Medway Design Review Committee Meeting
Monday, February 06, 2023
Zoom (Remote) Meeting

Project Review – 7 Sanford Street Multi-Family Special Permit Application

Medway Commons Site Plan – Chipotle and Starbucks, 67B and 67C Main Street

Milford Regional Hospital Medical Facility Master Signage Plan – 86 Holliston Street-

SITE PLAN

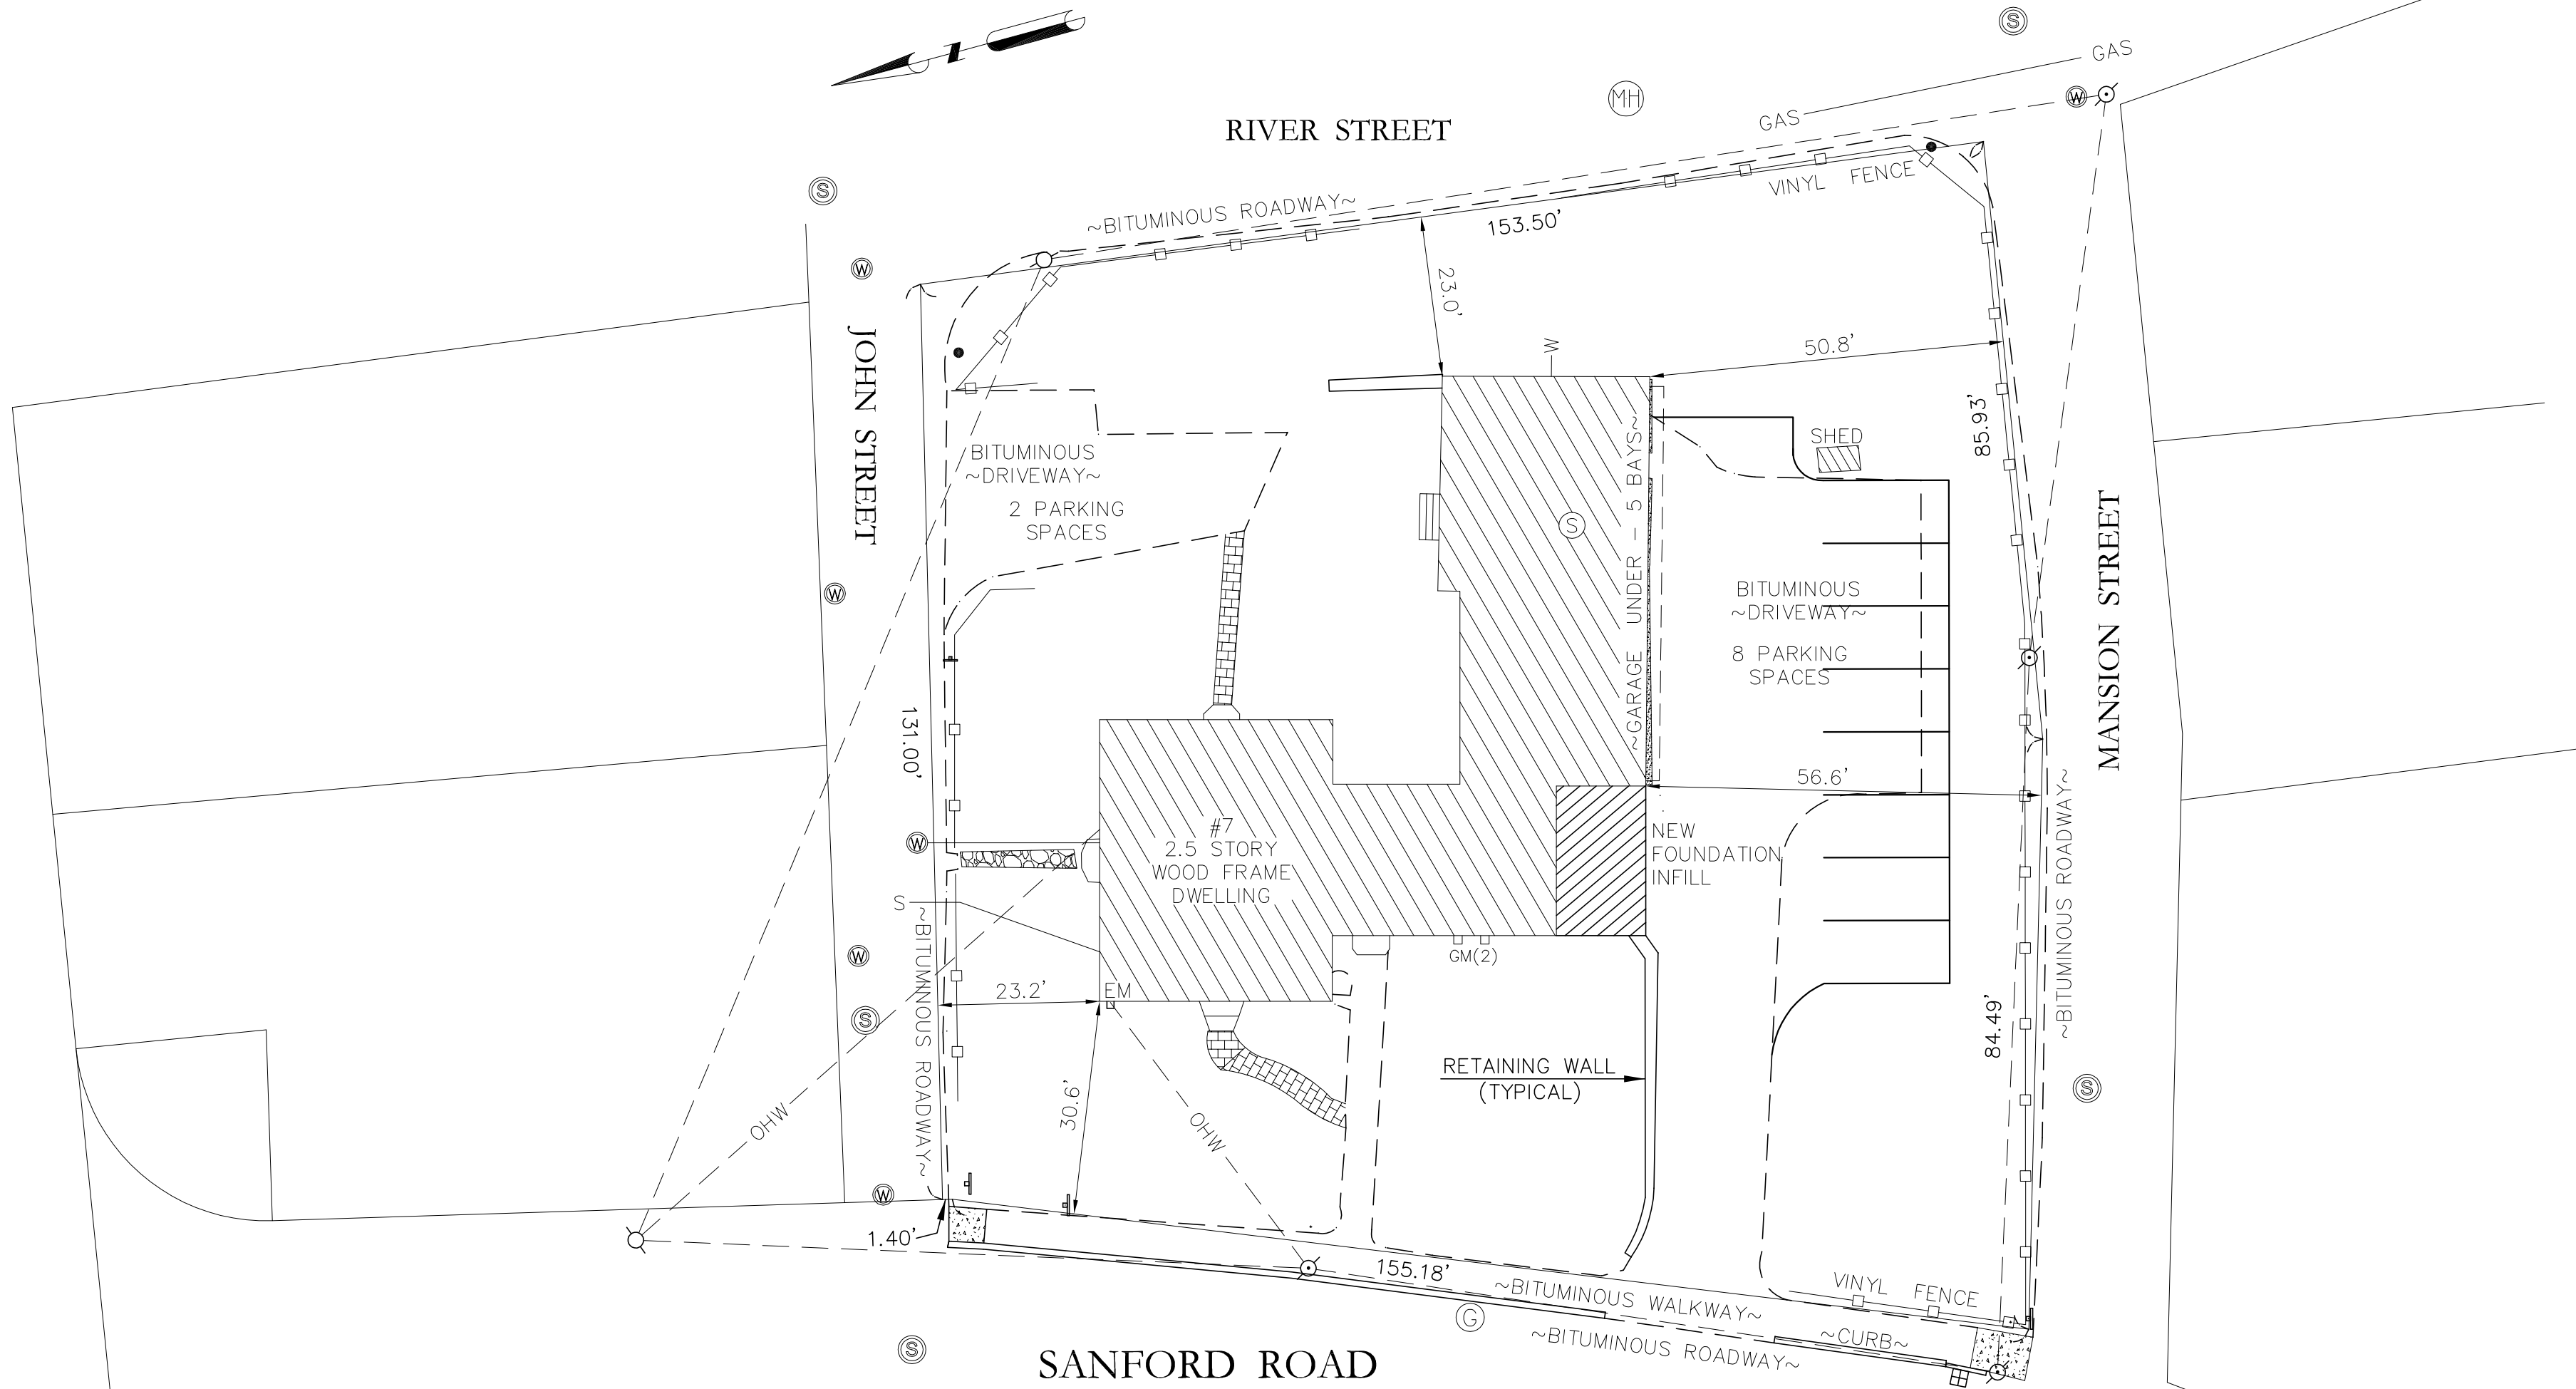
Project architect Brian Donahue said the original site plan indicates three parking spaces but there's possibility for adding two more bringing it to a total of five spaces. The existing bituminous area will be re-paved over time. He described the parcel topography. The plan is to re-pave the lower area to provide eight parking spaces adjacent to Mansion St. These spaces will be used for the new proposed units. They propose to replace the existing fence around the site's perimeter with cedar fencing and to add five trees. There is no fencing currently on the Sanford ST side of the property and there's no plan to add any fencing there.

Ms. Clifford suggested a more screened fence/buffer area where the new parking spots are being added on the south side of the property. Applicant agreed to explore that option. New walkways leading into the new units will be created. The first unit on the ground level will be an accessible unit (2-bedroom) with an accessible parking space. A storage unit will be provided for each of the 6 unit. 3 ft. knee walls will be added as part of the proposal and roof replacement is proposed for the new units. Hardiplank clapboard siding with composite shingles and replacement windows are planned. The exterior will be white with black sash and trim. It was suggested to investigate different color schemes for the building. Inside space will be identified for storing individual trash bins and an outside dumpster is not planned at this time. Mr. Buckley asked if the plan includes an outside gathering space. Adding awnings on the doorways was recommended. Ms. Clifford asked if solar panels are being considered for the project. Mr. Donahue said the option will be explored as the project progresses. She also suggested landscape lighting and paying attention to general lighting around the property. The first PEDB public hearing for the project is on Feb 14th. A DRC review memo for the project will be sent to PEDB before the hearing. Mr. Buckley will draft the letter.
